Project	IEEE 802.16 Broadband Wireless Access Working Group http://ieee802.org/16 >		
Title	Modifications to the Feedback Methodologies in UL Sounding		
Date Submitted	2008-01-14		
Source(s)	Fred Vook, Jeff Zhuang, Tom Krauss, E-mail: fred.vook@motorola.com Fan Wang, Krishna Sayana Motorola		
Re:	LB26 – IEEE802.16 REV2/D2.		
Abstract	This contribution proposes modifications to the feedback mechanism contained in the UL sounding signaling.		
Purpose	Review and adopt.		
Notice	This document does not represent the agreed views of the IEEE 802.16 Working Group or any of its subgroups. It represents only the views of the participants listed in the "Source(s)" field above. It is offered as a basis for discussion. It is not binding on the contributor(s), who reserve(s) the right to add, amend or withdraw material contained herein.		
Release	The contributor grants a free, irrevocable license to the IEEE to incorporate material contained in this contribution, and any modifications thereof, in the creation of an IEEE Standards publication; to copyright in the IEEE's name any IEEE Standards publication even though it may include portions of this contribution; and at the IEEE's sole discretion

Figure NNN – 18 subcarrier sounding band layout for transmitting direct covariance matrix feedback.

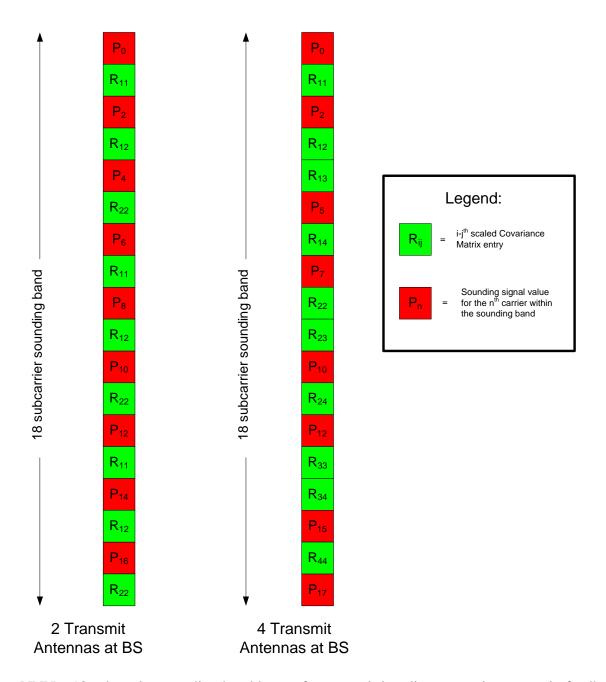
Figure NNN shows a sounding band format for use when the BS has two and four transmit antennas. The sounding band format with direct covariance matrix feedback contains two types of frequency domain symbols: P_n and R_{ij} . The symbol P_n is equal to the value of the sounding waveform value for the n^{th} carrier within the sounding band. The symbol R_{ij} is the $(i,j)^{th}$ entry of the \mathbf{R} matrix scaled by one over the square root of the scale factor β :

As shown in Figure NNN, certain sounding values that would have ordinarily been transmitted according to the settings within the UL Sounding Command IE are replaced with scaled analog values of the DL transmit covariance matrix.
